U. S. NUCLEAR REGULATORY COMMISSION

AUGMENTED INSPECTION TEAM

Report No. 50-255/87019(DRP)

Facility Name: Palisades

FIGURE 1

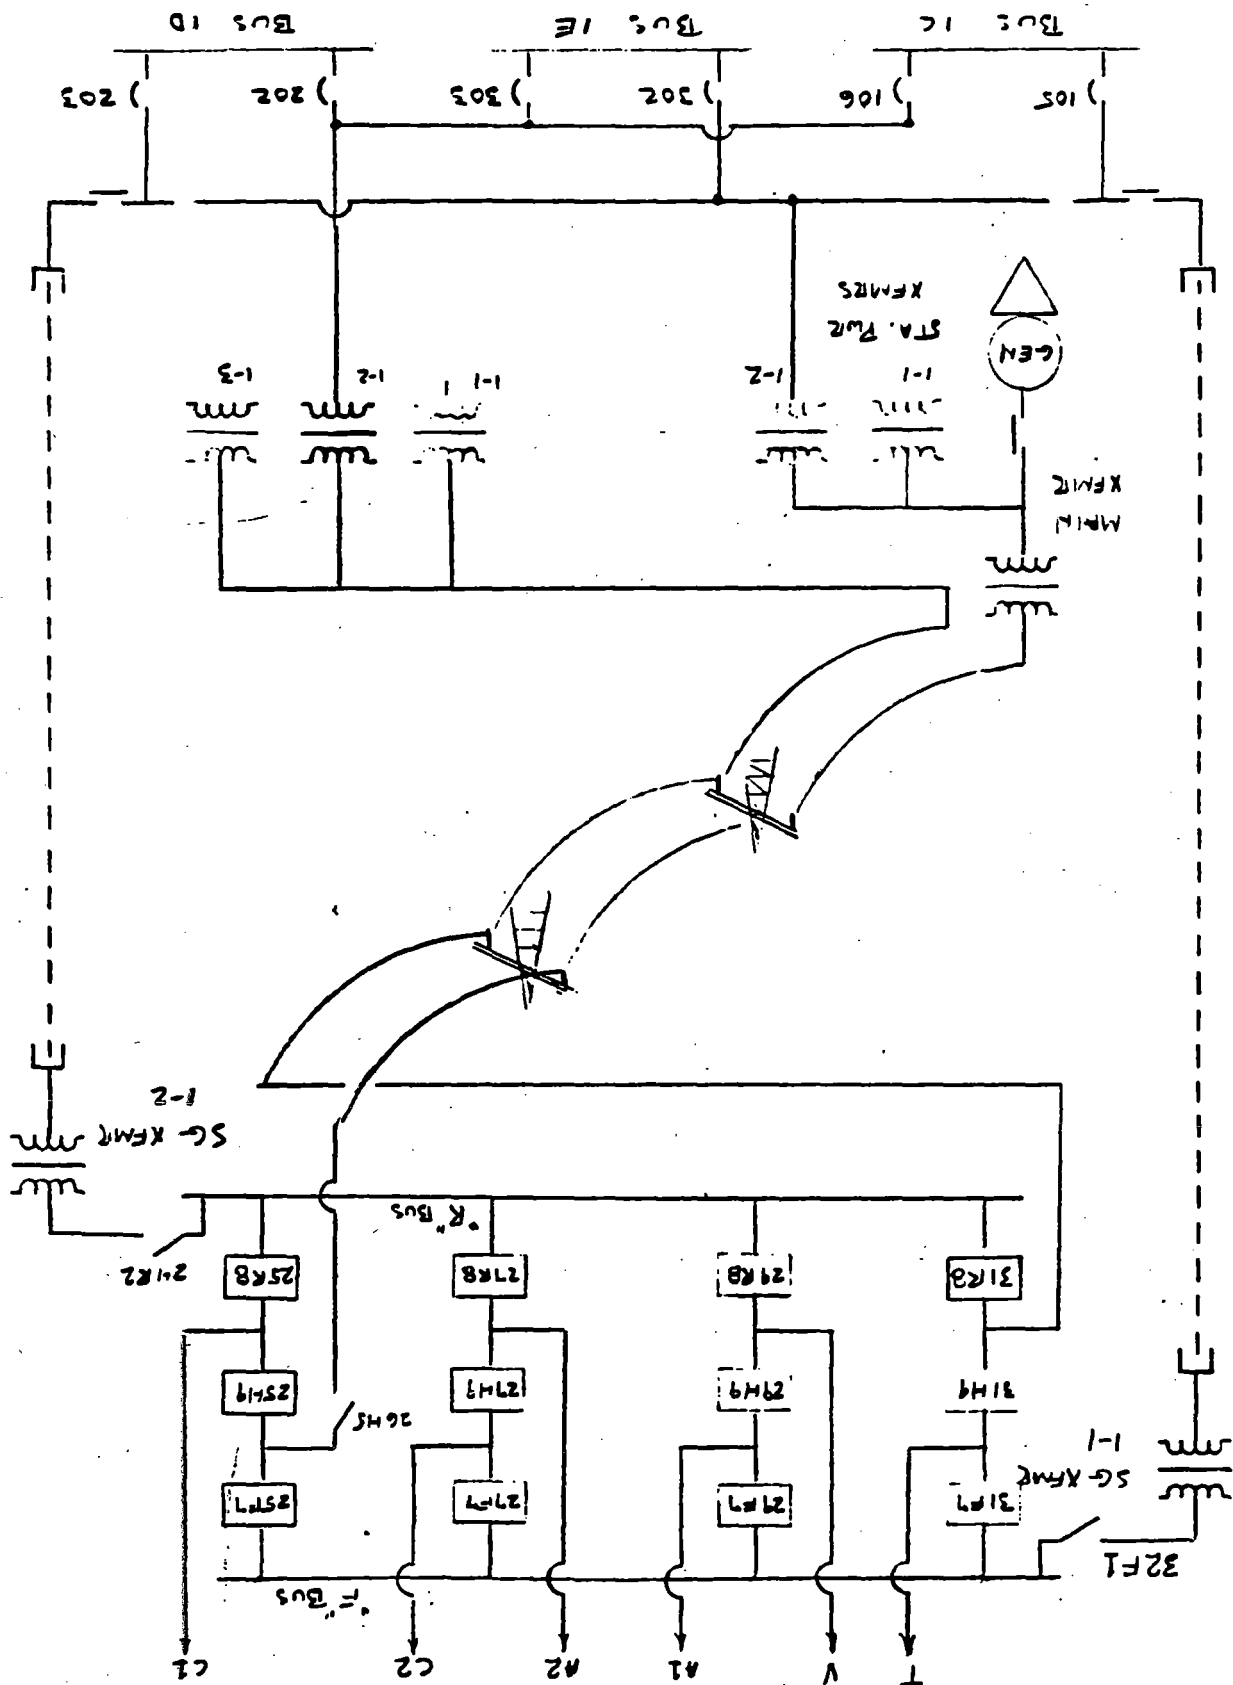
The Palisades offsite power system (Figure 1) consists of a switchyard, six transmission lines connecting the grid network to the switchyard, and an immediate and delayed access circuit connecting the switchyard to the onsite Class 1E distribution system. The immediate access circuit consists of a 345KV transmission line, 345KV to 24KV Startup Transformer 1-2 which failed July 14, 1987, and a 2400 volt bus duct. The delayed access circuit consists of 345KV transmission line, 345KV to 24KV main transformer, 24KV bus duct, 24KV to 2.4KV station power transformer (No. 1-2), and 2.4KV bus duct.

- (1) The offsite circuits between the switchyard and Class 1E safety buses marginally meet the design requirements of GDC-17.
- (2) The single transmission tower line for both immediate and delayed access circuits between the switchyard and the startup and main transformers is vulnerable to a single event which could cause both circuits to be lost and does not meet current NRC standard review plan recommended practice for two physically separate lines.
